UNITED STATES PATENT AND TRADEMARK OFFICE

Office Action Summary

10/828,993

DETAILED ACTION

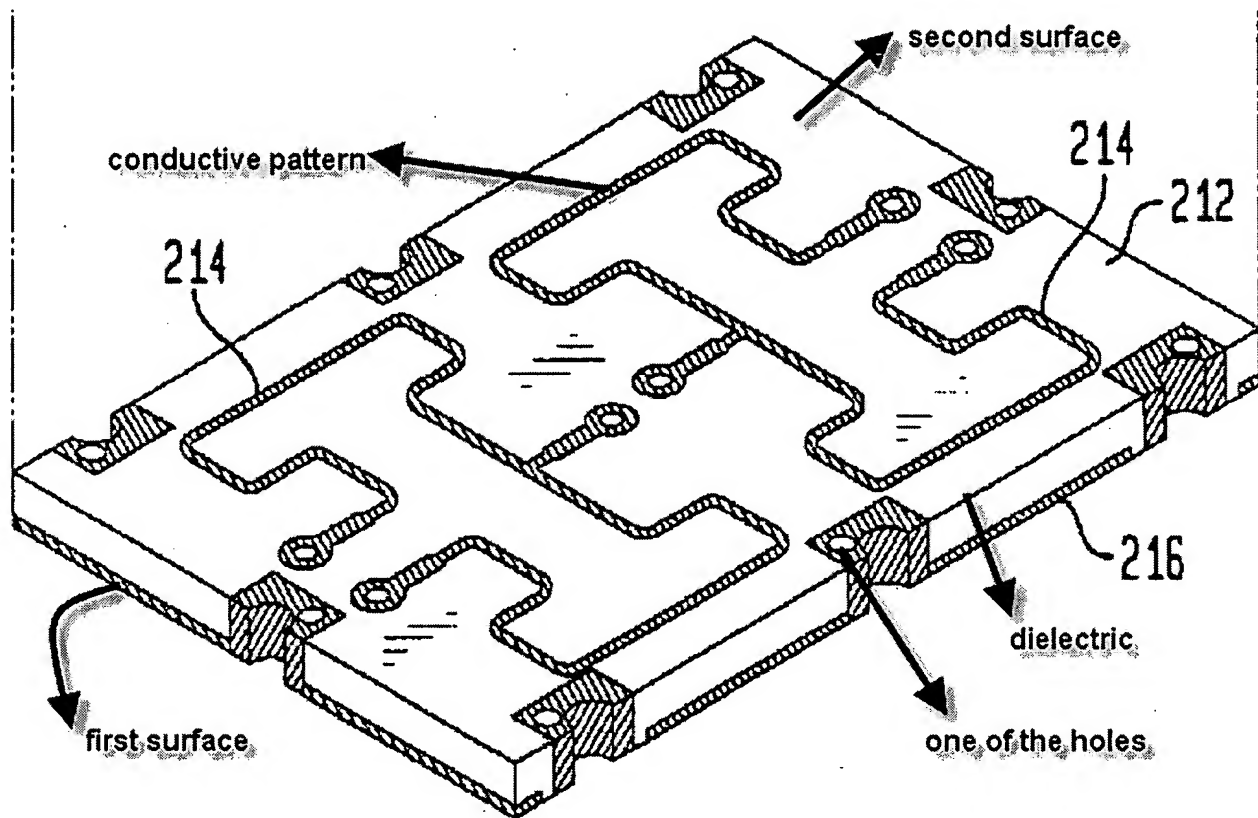
As to claim 29, Sridharan discloses a radio frequency (RF) component comprising: a dielectric layer (Figure 9, element 212) having opposing first (Figure 9, bottom side) and second major surface (as indicated in the figure below) being free from a semiconductor substrate, the dielectric layer (Figure 9, element 212) having a plurality of openings (as indicated in the figure below) between the first and second opposing major surfaces; and a patterned conductive (Figure 9, as indicated below) layer on the second major surface of the dielectric layer, wherein the plurality of openings are

arranged in a predetermined pattern along laterally opposing sides of the patterned conductive layer (as shown in figure below).

As to claim 35, Sridharan discloses the RF component wherein the plurality of openings are laterally adjacent portions of the patterned conductive layer with no openings extending through the patterned conductive layer (as shown in the figure above the holes adjacent to the edges (as indicated in the drawings above) are not extending through the patterned conductive layer.

As to claim 36, Sridharan discloses the RF component wherein each of the plurality of openings is cylindrically shaped (as shown in figure above).

As to claim 37, Srindharan discloses the RF component wherein there is substantially uniform spacing between the adjacent openings on each of the opposing sides of the patterned conductive layer (as shown in the figure above the spacing between holes is uniform).

8. With respect to the applicant's assertion on page 4, third paragraph alleging that "Sridharan does not teach a dielectric layer having opposing first and second major, the first surface being free from a semiconductor substrate", the examiner disagrees. As indicated in the rejection above, the figure shown above clearly illustrates dielectric layer having two surfaces with through holes, wherein first surface is free from a semiconductor.
